ADDENDUM NO. 1 TO PROJECT NO. 44242

**PROVIDE MODIFIED BITUMEN ROOFING,
ADMINISTRATION AND RESIDENTIAL WINGS, BUILDING NO. 68
BROOKWOOD SECURE CENTER
419 SPOOKROCK ROAD
CLAVERACK, NY 12513**

July 25, 2012

DRAWING NUMBER:
A-101

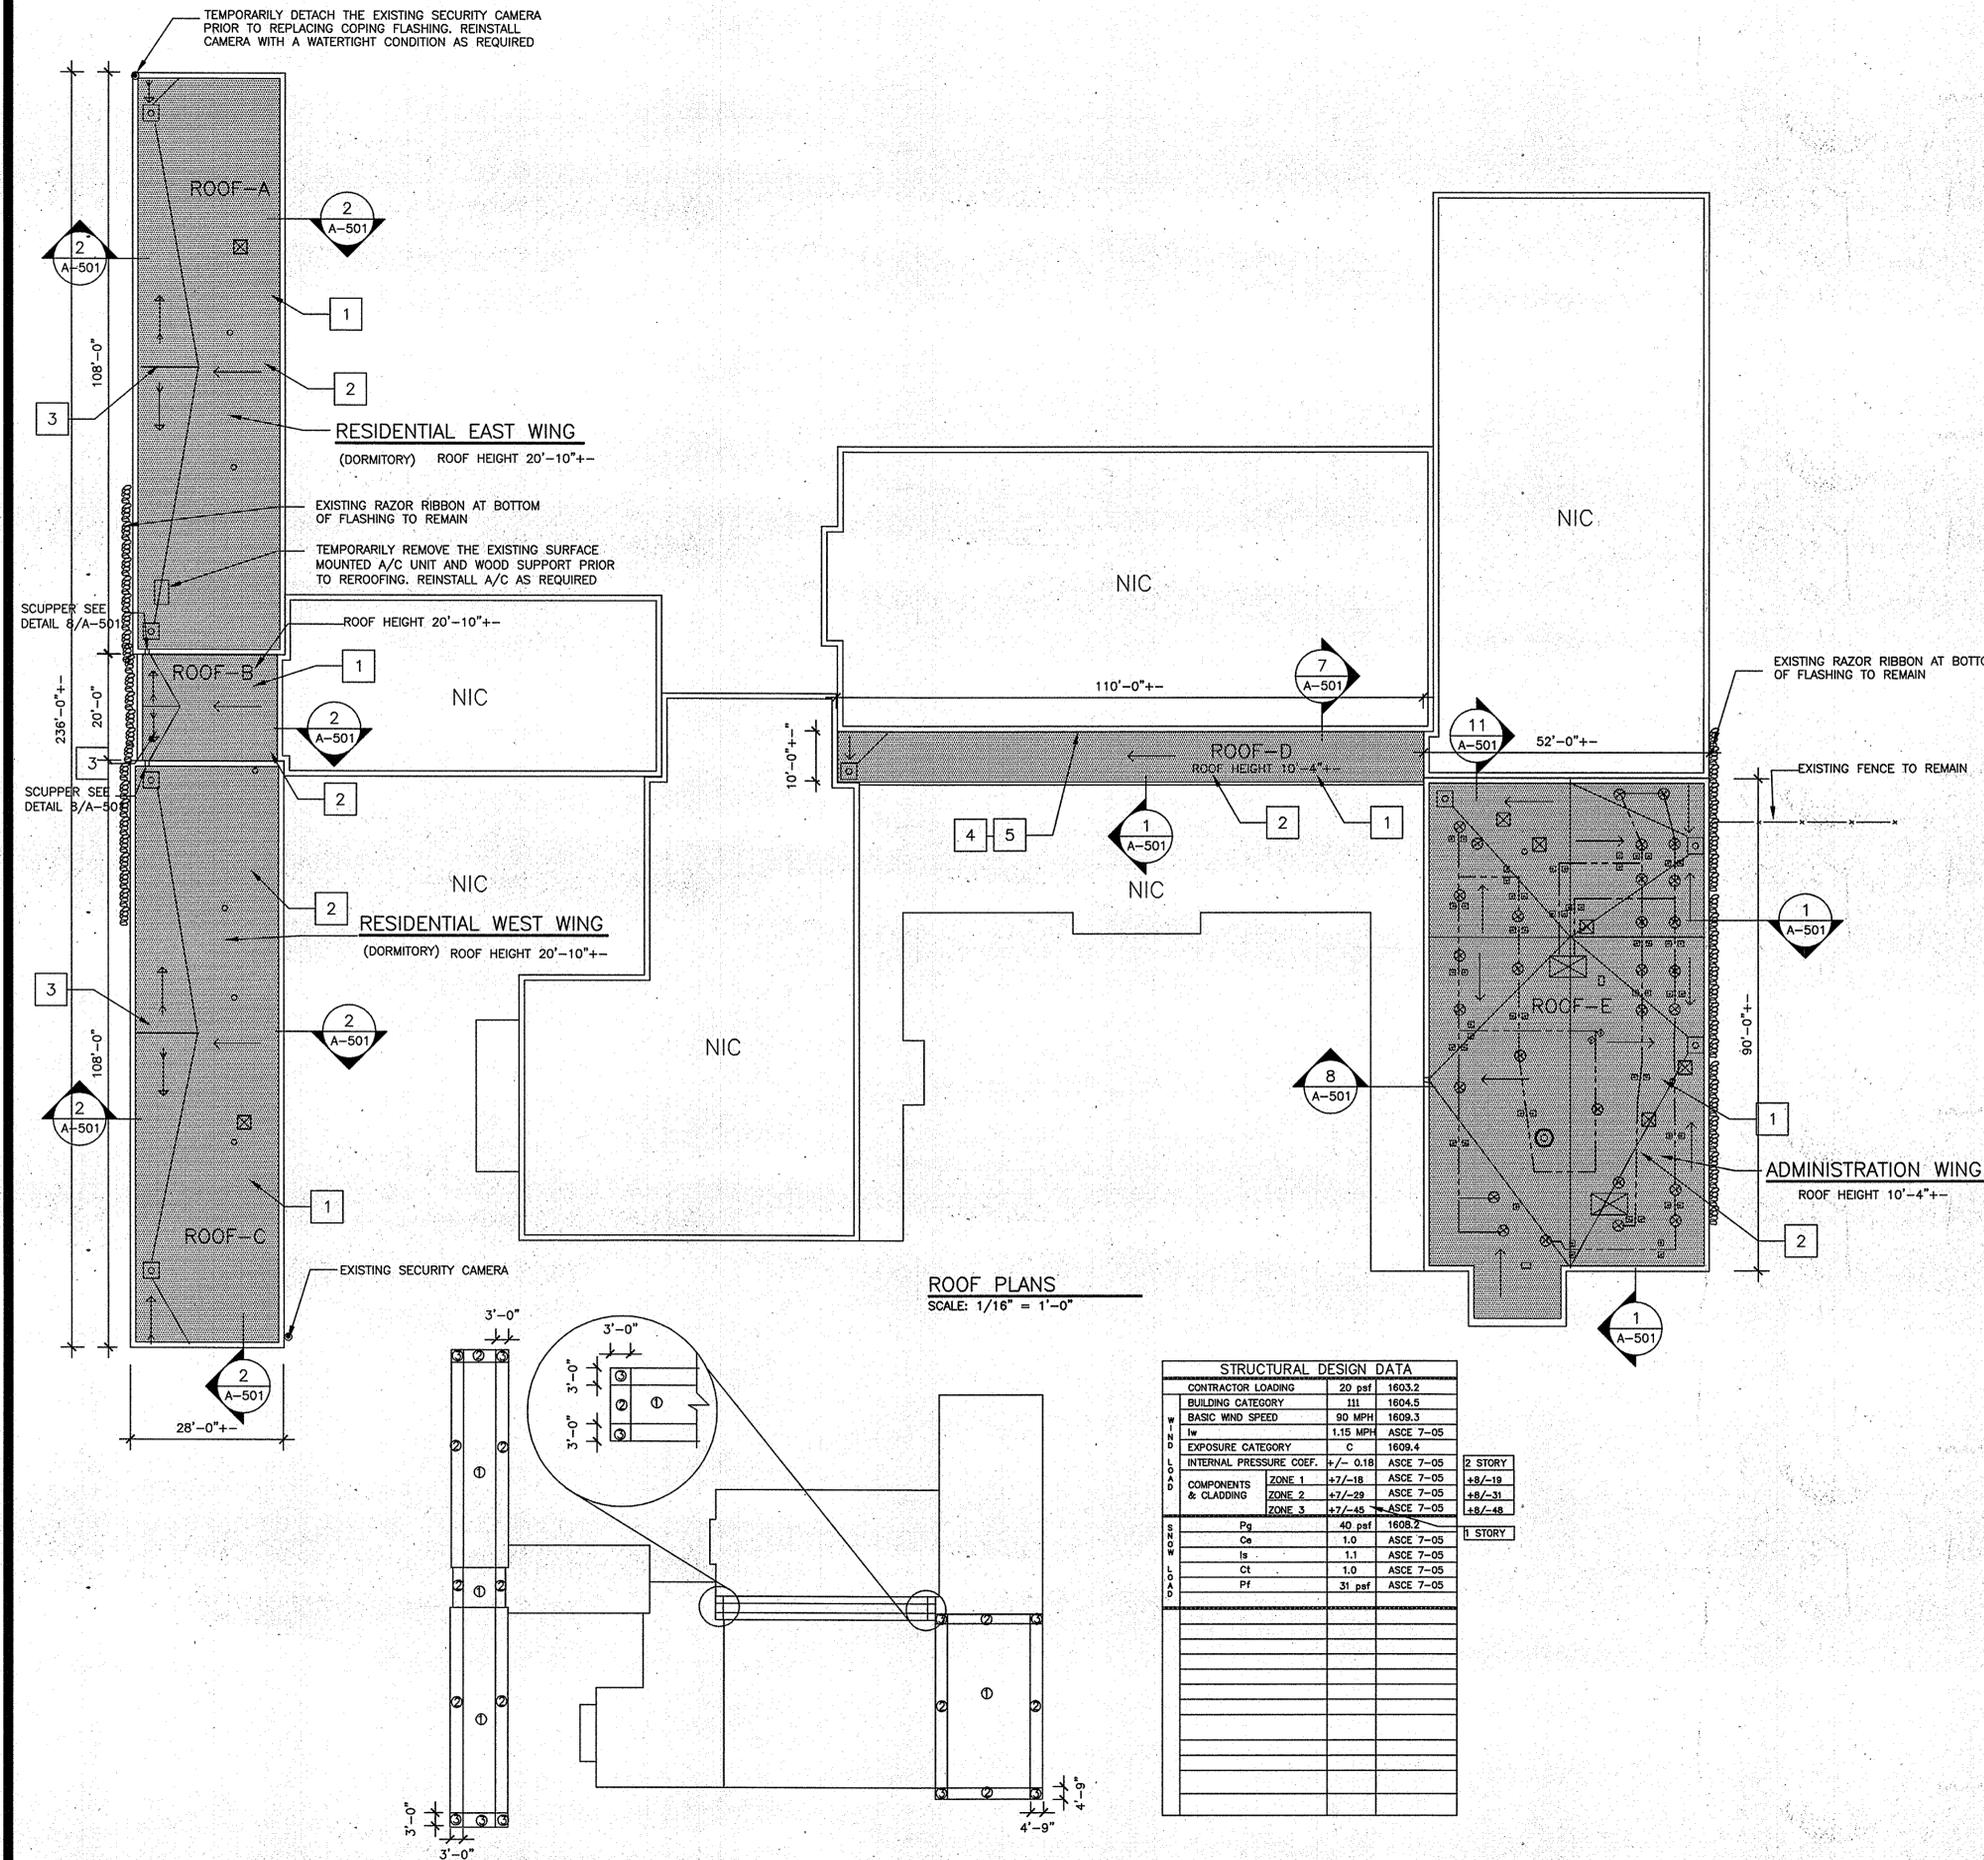
1. Discard Drawing A-101 dated 07/04/2012 and replace with the attached Addendum Drawing A-101 dated 07/19/2012.
2. Drawing A-501, PITCH POCKET DETAIL, Change detail indicator number from 8 to 9.
3. Drawing A-501, HOT STACK FLASHING, Change detail indicator number from 9 to 10.
4. Drawing A-501, EXPANSION JOINT DETAIL, Change detail indicator number from 10 to 11.
